# APPEAL OF DECISION

New File # 12-B-24-OB

## Middle Housing Staff Review

**TO:** R. Bentley Marlow, Contractor  
**FROM:** Planning Staff  
**DATE:** November 20, 2024  
**SUBJECT:** Middle Housing Review – 10-E-24-MH (3<sup>rd</sup> revision)  
**ADDRESS:** 1214 Callaway St (Parcel ID 094FQ017)

# SITE PLAN

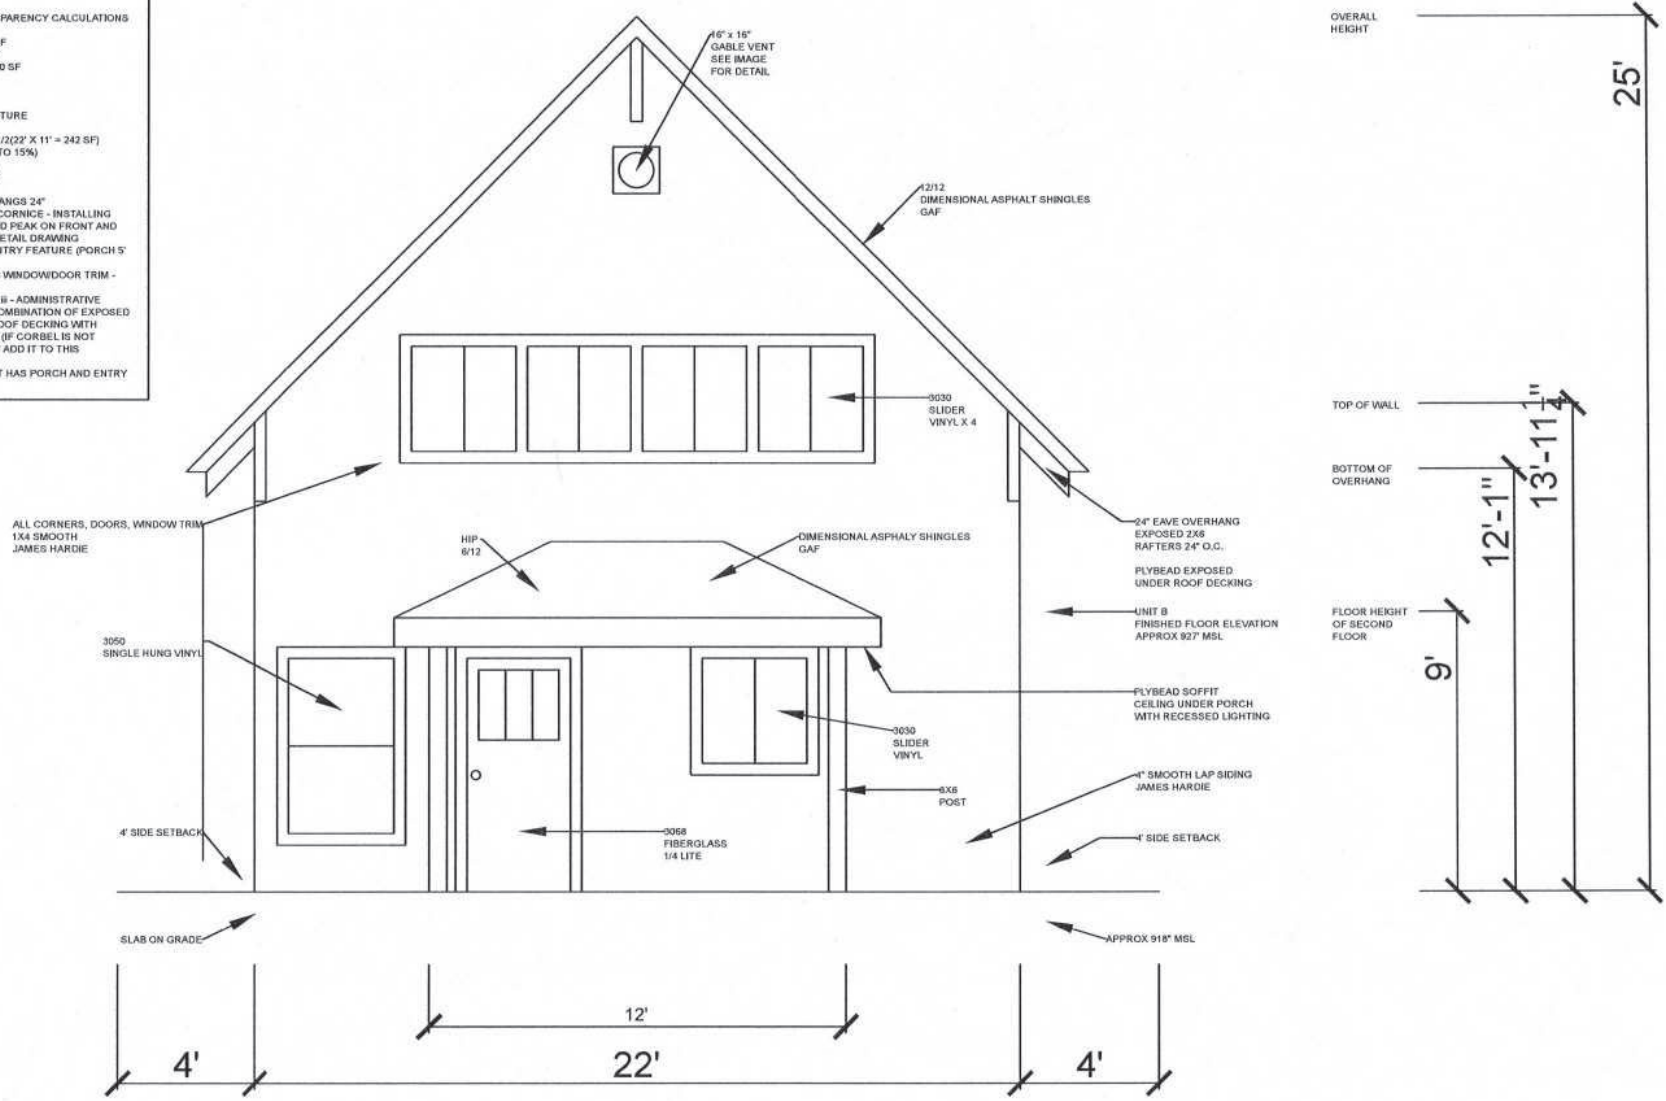
- The proposed front setback (shown as 94.58') does not meet the zoning standard in Article 4.6.c.3.a: *"front setbacks for middle housing types shall be the average of the blockface, plus or minus five feet, in no case less than 10'.*

- The proposed duplex does not meet the front setback requirement of Article 4.6.C.3, which states "front setbacks shall be the average of the blockface, plus or minus five feet, in no case less than 10 feet."

- The proposed duplex does not meet the 5' minimum interior side setbacks and requests two administrative variations of 20% on each side setback, reducing both side setbacks to 4'. The building meets the 15' minimum rear setback requirement.

- The application includes two administrative variations requests for interior side setbacks, reducing each by 20% to 4 feet.
  - Per City Engineering, Utility and Drainage Easements are dedicated on the plat and would conflict with the proposed structure. Those easements would need to be closed where structures would overlap.

Art. 2.4.O.2.b defines 'Front Setback' as "a front setback is the MINIMUM distance per the zoning district that a principle building must be located from the front lot line." The site plan submitted complies with Art. 4.6.C.3.a "Front SETBACKS for Middle Housing" as the proposed new structure is setback approx. 95' feet from the front lot line, which complies with the requirement of "in no case less than 10 feet." Moreover, the original primary structure, (Front Setback 13'6") whose conversion to a Middle Housing Duplex has been approved, satisfies the Front SETBACK for this parcel.

# FRONT ELEVATION

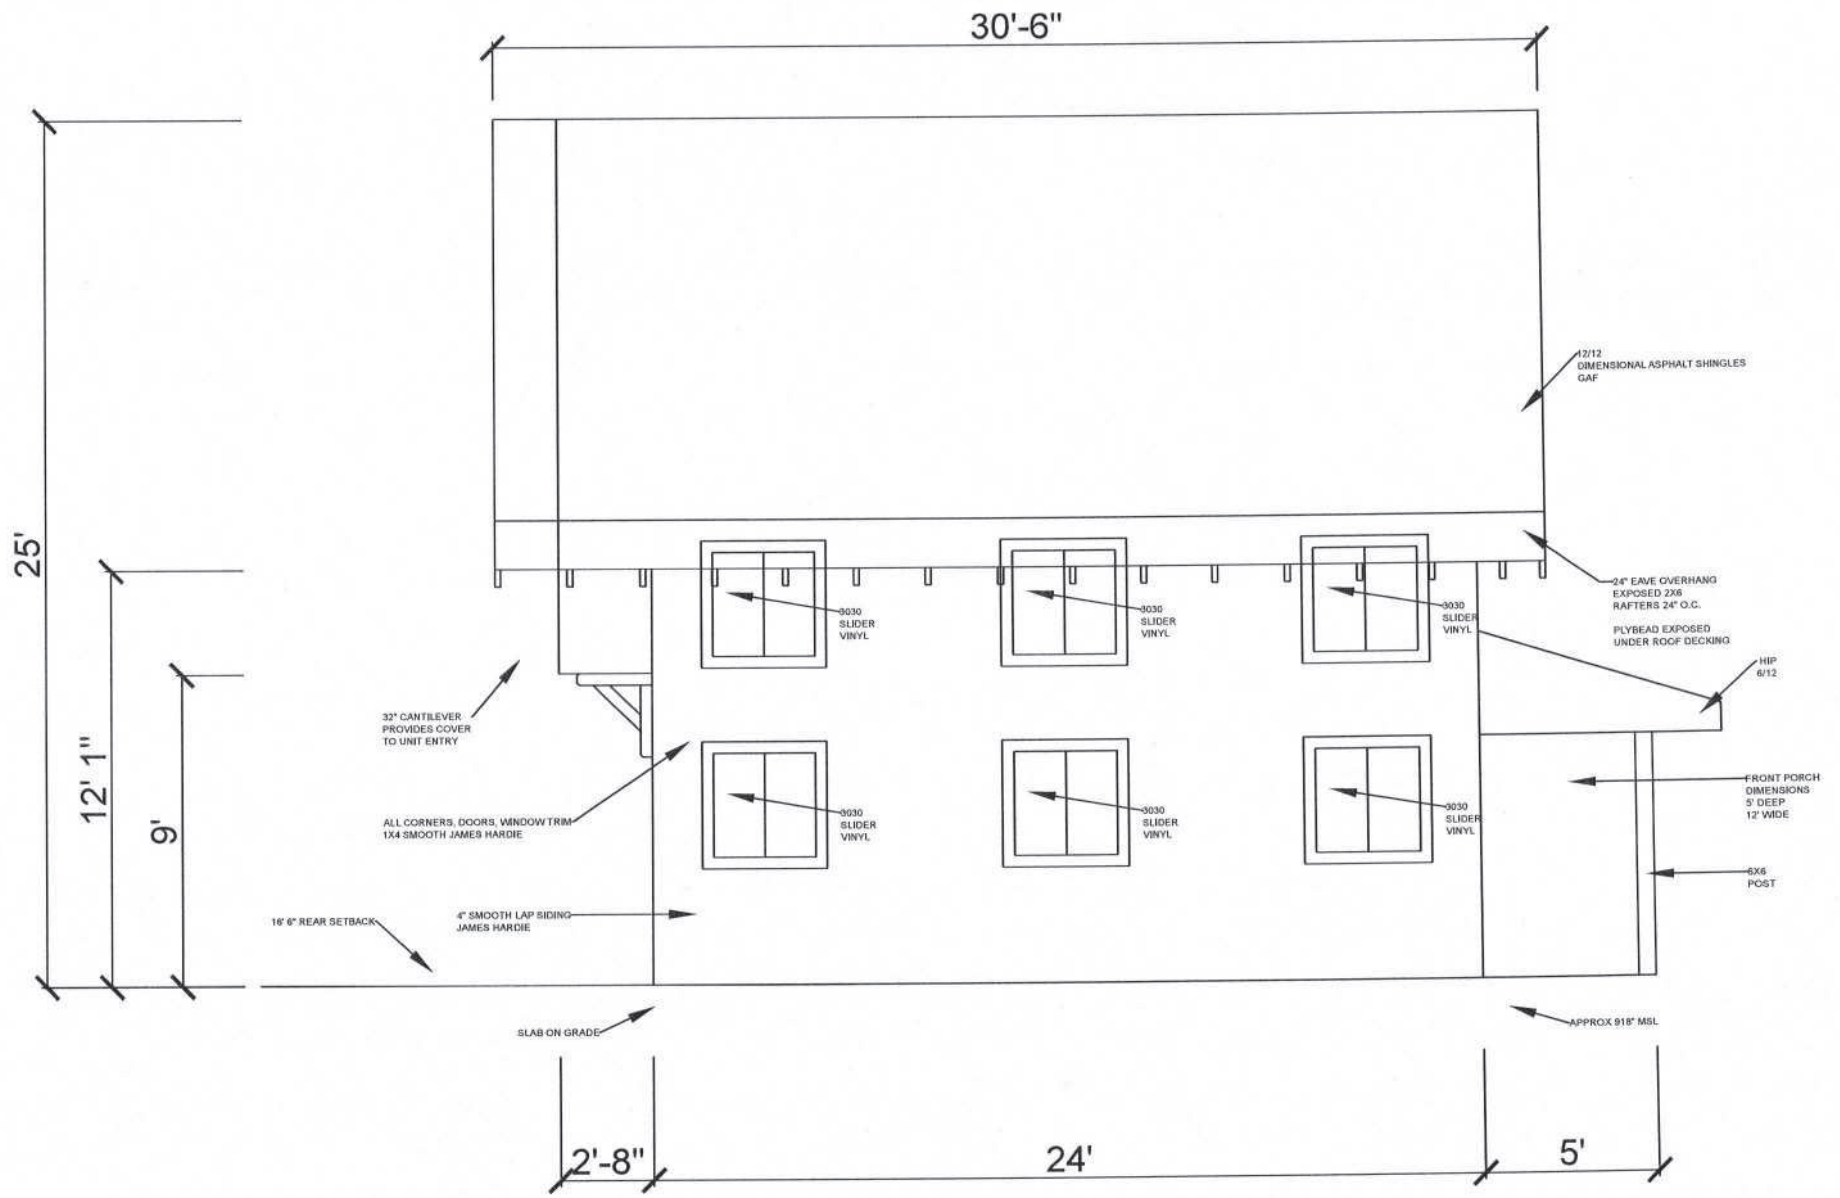
- The duplex is oriented with the front elevation facing the rear of the existing building, with ground level entrances oriented towards the street but obscured by the existing building.

- The roofline is steep, with a 12/12 pitch. The drawings dated 11/18/24 have been revised to accurately depict the roofline.
- To satisfy Article 4.6.E.4.c, the project includes: one stoop, 24" eave overhangs and articulated window and door trim, including window sills (projecting sills shown on separate profile but not indicated on elevation drawings), and requests an administrative variation to incorporate exposed rafter tails and triangular brackets as an additional design element.
